# Groundwater Application Review Summary Form

Application # G- 19397

GW Reviewer Stacey Garrison Date Review Completed: 5/23/2024

**A. GENERAL INFORMATION:** Applicant's Name: Westwood Farms, Inc (John Coleman) County: Marion

Water-Level Measurements in Nearby Wells

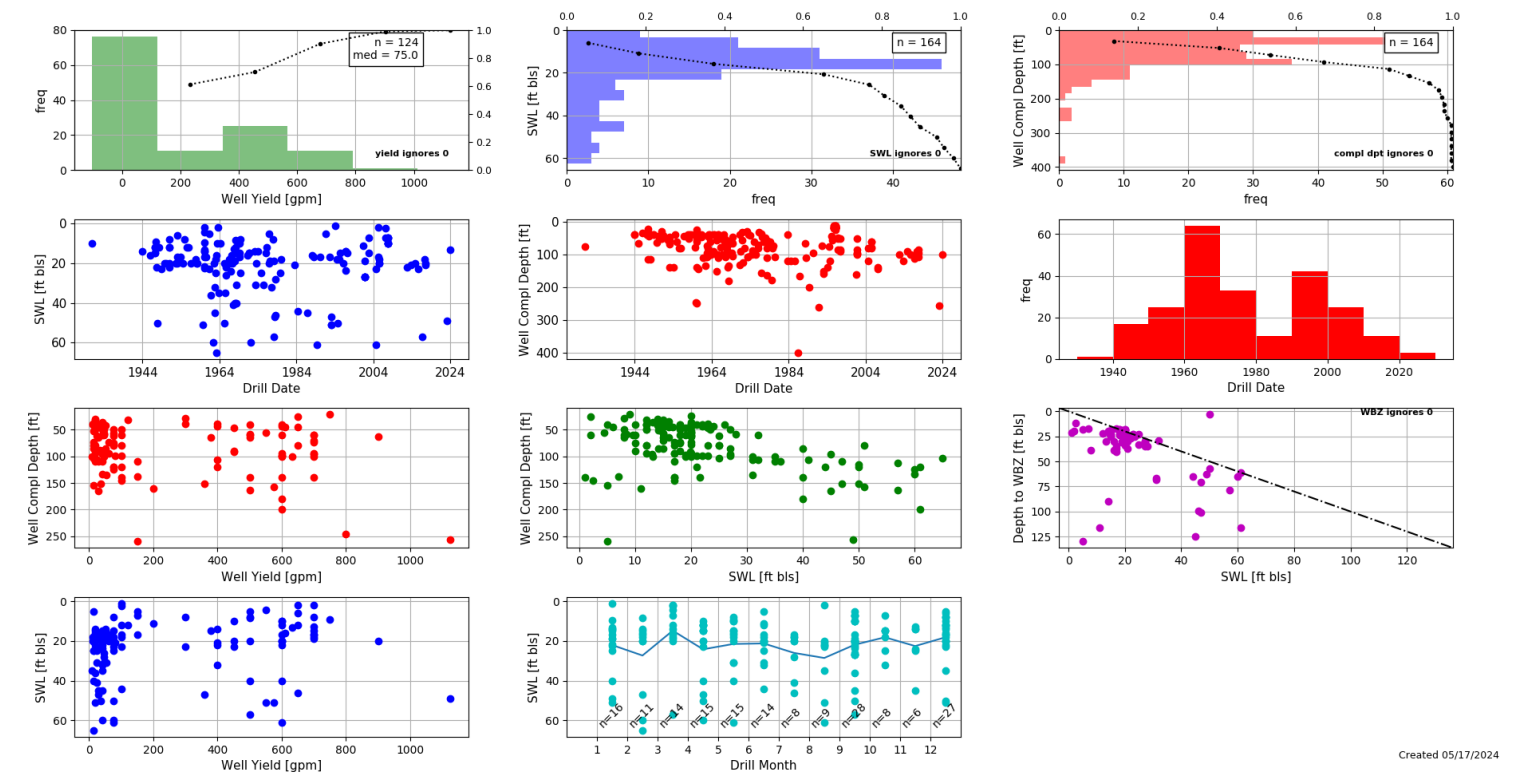
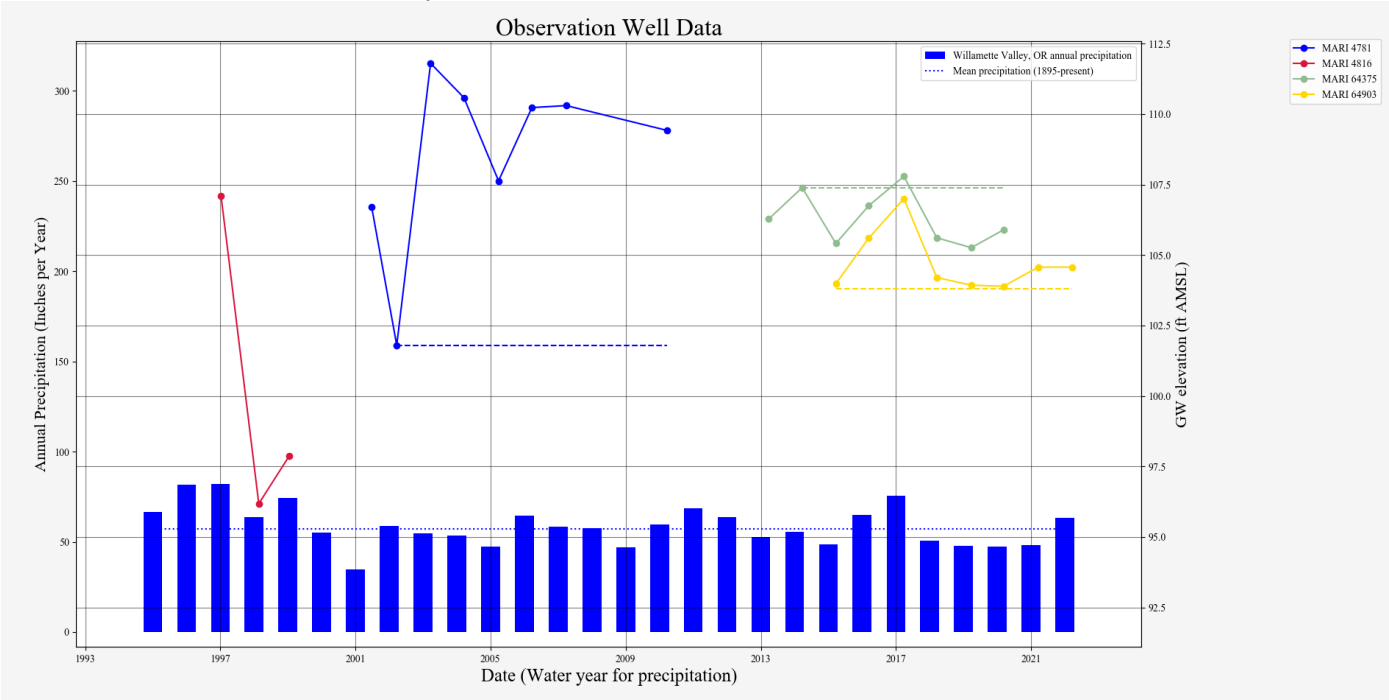
Water level trends for nearby (within 2 miles of POAs) wells that utilize alluvial aquifers appear to be stable (see [Water Levels Measurements in Nearby Wells](#)). All the selected wells are located on Holocene floodplain deposits, with nearly all water levels within 10 feet of the elevation of the Willamette River levels (Gannett and Caldwell, 1998; Woodward et al., 1998). Wells completed in the Holocene floodplain deposits are closely tied to the stream stage of the Willamette River (Conlon et al., 2005). As a result, groundwater levels in the Holocene floodplains deposits are anticipated to be stable in the long-term, but seasonal fluctuations may be pronounced, particularly in late summer (see [Gage Height for USGS 14191000](#)). It appears that the proposed use is within the capacity of the resource.

**Theis Interference Analysis**

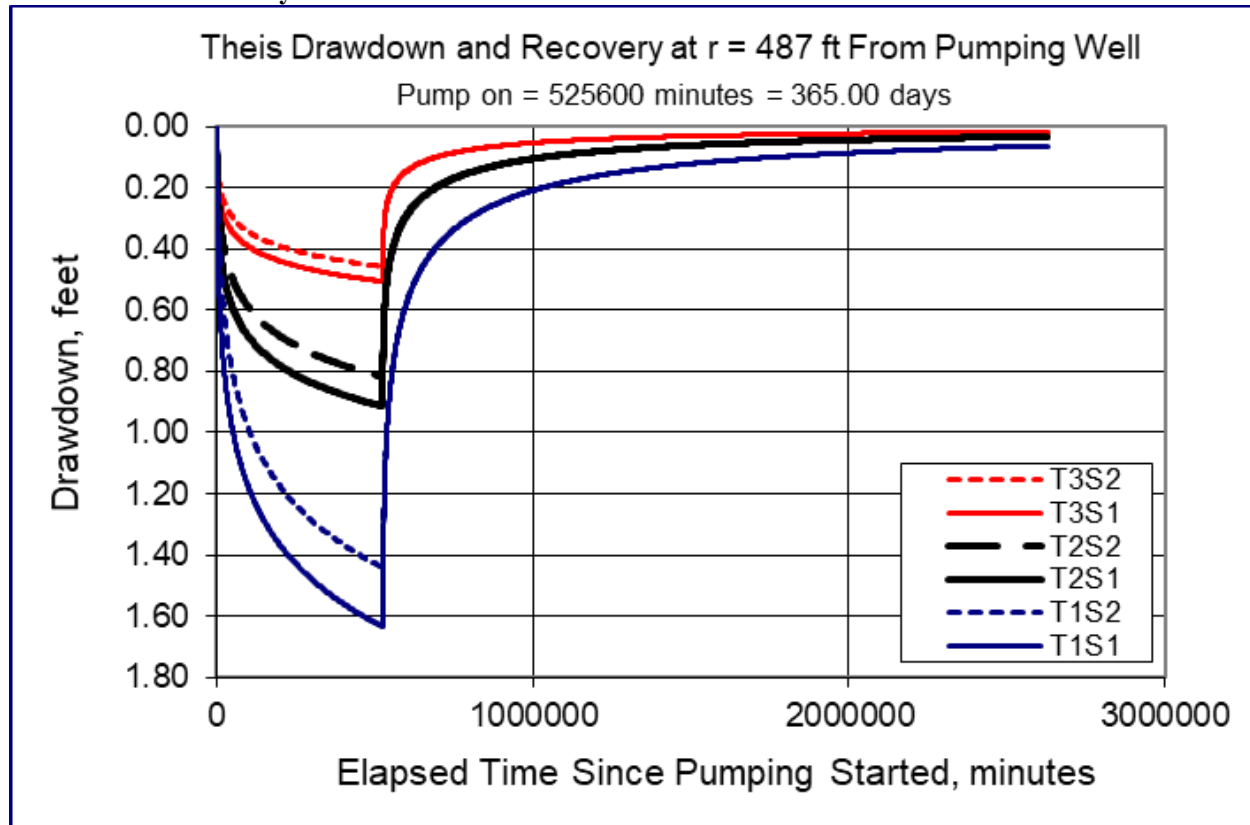
The nearest groundwater user to POA 1 (**MARI 4850**) and POA 2 (**PROP 473**) that is not on a taxlot with the same owner is **MARI 4801/4800** (POA on Claim GR 3327), with an estimated location 937 ft northeast of POA 1 (**MARI 4850**) and 487 ft northeast of POA 2 (**PROP 473**), at an elevation of ~119 ft msl. **MARI 4801/4800** is completed to a depth of 55 ft bls (64 ft amsl). It is likely the proposed use would cause some degree of well-to-well interference with **MARI 4801/4800**. To assess the degree of drawdown, a Theis drawdown analysis was conducted for the proposed use (see [Theis Drawdown Analysis](#)). Because only the distance is expected to vary between the two POAs (**MARI 4850** and **PROP 473**) and the nearest groundwater user (**MARI 4801/4800**), only the POA-nearest user pair with the shortest distance (in this case, POA 2/**PROP 473** and **MARI 4801/4800**) was analyzed quantitatively for well-to-well interference. All other POA-nearest user pairs would presumably result in less interference due to their greater separation. Results indicate that the proposed use is not likely to cause well-to-well interference with **MARI 4801/4800** that exceeds the threshold under the standard condition for alluvial aquifers in the Willamette Basin.

Radial distance from pumping well ( $r$ )=487 ft [estimated radial distance to nearest user, MARI 4801]

**Pumping Rate ( $Q$ )= 0.61 cfs (273.8 gpm)**

Aquifer Transmissivity ( $T1$ )= 112,200 gpd/ft (15,000 ft<sup>2</sup>/day), ( $T2$ )= 224,400 gpd/ft (30,000 ft<sup>2</sup>/day), ( $T3$ )= 448,800 gpd/ft (60,000 ft<sup>2</sup>/day)

Storativity ( $s1$ ) = 0.15, ( $s2$ ) = 0.30 [Heath 1983 and Morris & Johnson 1967, values for specific yield in gravel and sand]

Total pumping time = 245 days

Based on this analysis of the available data and under the assumptions previously identified, groundwater for the proposed use will likely be available in the amounts requested and within capacity of the resource. The conditions specified in B1(d)(i) and B2(c) are recommended to protect senior users and the groundwater resource.
